Report VA1820.190724.ADR

18 Iron Bridge Close, London

Acoustic Design Review

24 July 2019

Figure 3.2

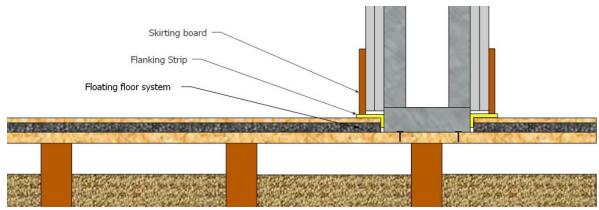
It is recommended that the ceiling be interrupted at party walls. At the head of the wall, the channel should be attached to the underside of a joist or the soffit, with the ceiling running to either side of the lined partition. The joint should be sealed with a non-hardening mastic sealant.

It is recommended that the floor channel is attached directly to the subfloor deck or concrete floor, with the acoustic underlay running to the sides of the lined partitions, and flanking strips to the edges to maintain the discontinuity between the subfloor and the isolated floor, returned to underneath the skirting boards. This is indicated in Figure 3.2.
